# Access Compliance Report

## Public Rights-of-Way

Intersection ID: 29161	Main Street: MT_HOLLY-HUNTERSVILLE_RD	Cross Street: FIRESTREAK_DR	Location: SW
ADA ID: EAFF4B73AED3	Ramp Type: Perp	Initial Pass/Fail: Fail	Overall Compliance: No
Severity Score: 10			
Codes/Mitigation Info/Possible Solution		Field Measurements/Component Compliance

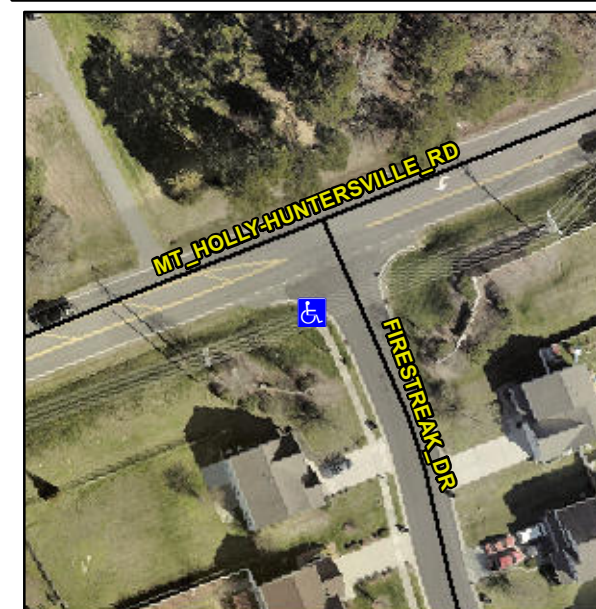
**R304.5.1, R304.5.3**

Compliance	Description	Data	Compliance	Description	Data
N/A	Ramp Length (in)	48.0	Yes	Ramp Slope (%)	6.6
No	Ramp Width (in)	40.5	No	Ramp XSlope (%)	3.4
N/A	Flare Type LT	N/A	N/A	Flare Type RT	N/A
N/A	Flare Slope LT (%)	N/A	N/A	Flare Slope RT (%)	N/A
N/A	Flare Traversable LT?	N/A	N/A	Flare Traversable RT?	N/A
N/A	Landing Length (in)	N/A	N/A	DWS Provided?	N/A
N/A	Landing Width (in)	N/A	N/A	DWS Contrast?	N/A
N/A	Landing Slope (%)	N/A	N/A	DWS Length (in)	N/A
N/A	Landing X Slope (%)	N/A	N/A	DWS Full Width?	N/A
N/A	Landing Curb? (Y/N)	N/A	N/A	DWS Offset (in)	N/A
N/A	Shared Landing?	N/A			
N/A	Gutter Ponding?	N/A	N/A	Gutter Slope (%)	N/A
N/A	Gutter Lip Ht (in)	N/A	N/A	Gutter X Slope (%)	N/A
N/A	Painted X Walk1?	No	N/A	Painted X Walk2?	N/A
	X Walk 1 Direction	To E		X Walk 2 Direction	N/A
N/A	X Walk 1 Width (in)	N/A	N/A	X Walk 2 Width (in)	N/A
	X Walk 1 Slope (%)	0.3		X Walk 2 Slope (%)	N/A
	X Walk 1 X Slope (%)	3.6		X Walk 2 X Slope (%)	N/A

**Remove & Replace Entire Ramp.**
